## Memorandum

Project Name and Address: Project Analysis Comments Response  
725 University Avenue  
Los Altos, CA 94022

IR Project No: P2019-067

## Comments / Response

### Standard #9

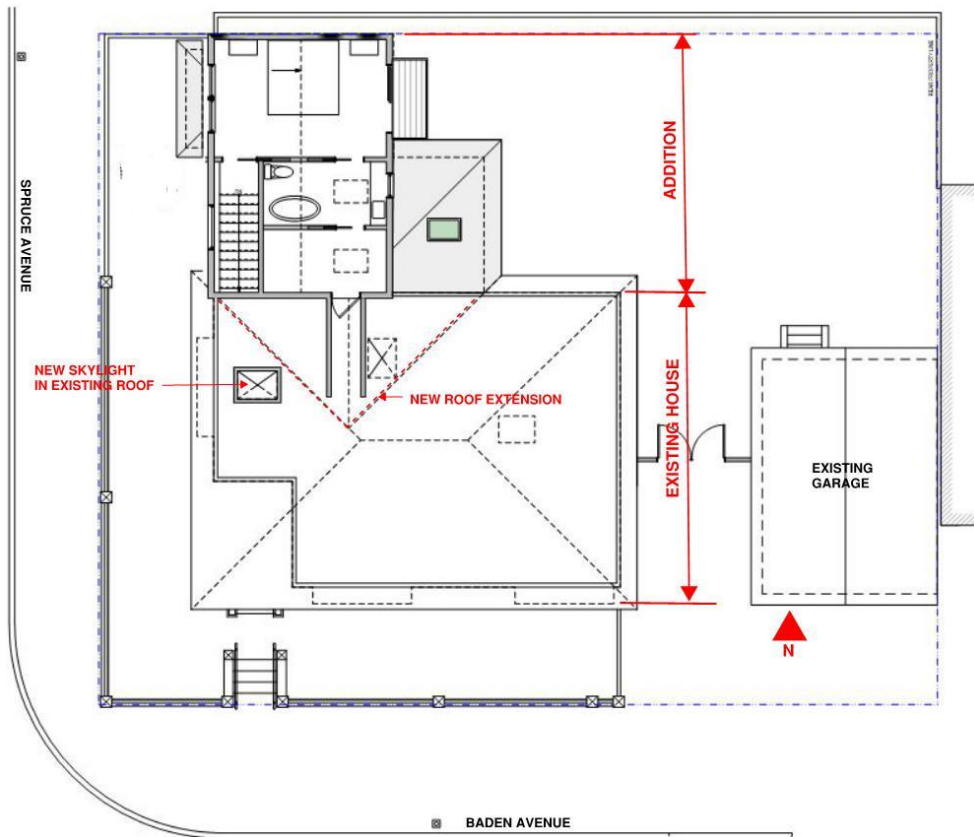
On Monday March 2<sup>nd</sup>, the property owner, Eric Albert and Assistant Planner Sean Gallegos met to discuss the project. Mr. Gallegos asked for a commentary on how the new work would be distinct from the existing to informed observers. This request is pertinent to Standard #9:

This standard seeks to discourage “false historicism”; however, implicit in this standard is the idea of scale and quantity. The application is commonly understood to address larger additions with additional footprint, or additions that add substantial height. For example, the following project involves a rear, connected two story addition to a small, simple craftsman house constructed in 1906. The application of this standard is rigorous in creating distinctions between the original house and the addition using a diminished footprint, mass, cladding materials and color. The task is to allow the original house to predominate while clearly making a distinction

Second Floor Plan

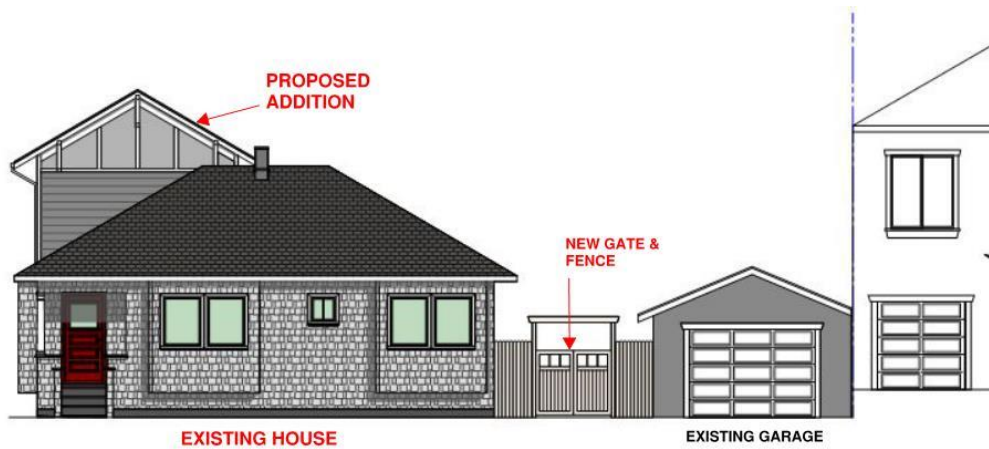
The project at 725 University Avenue is comprised of disparate elements located out of view, for the most part at the heavily altered rear of the property. Because there is no single addition or additional footprint, and the alterations are small in scale it is architecturally difficult to make a distinction between the original fabric and the new work. For example: the project proposes connecting the discontinuous spaces at the northeast corner of the second floor which requires a new wall that aligns with the two original walls:

Existing Second Floor

Proposed Connection and Enclosure

To use a differ cladding material to make a distinction at this type of architectural condition at this scale serves no purpose relative to the intent of Standard #9. Similarly, the proposed window removal to be replaced with a French door on the rear elevation, does not lend itself to an observable or material distinction. The only option for making a distinction would be to use a sliding glass door which is not compatible with the architectural language of the house.

Street Elevation (front)

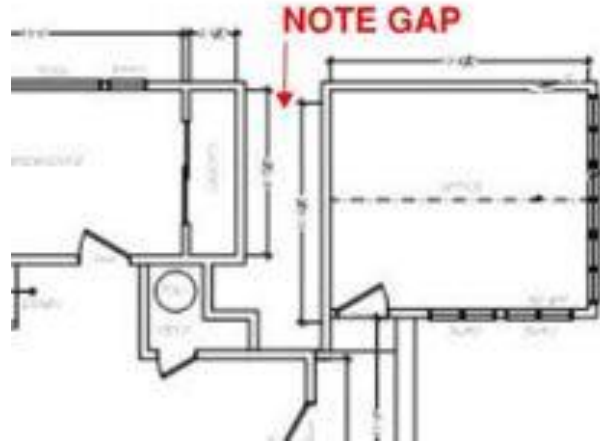
On the other hand, the original design proposed a dormer at the front elevation, observable from the street. Based on the character defining features described in the DPR forms, the main roof lines are important and the addition at this location would compromise the building's character and add an observable inappropriate feature. The design team opted for the use of skylights at this location as an alternative. This decision complies with Standard #9 in that it makes clear that this feature is new, very low profile, and architecturally neutral in terms of the architectural language.
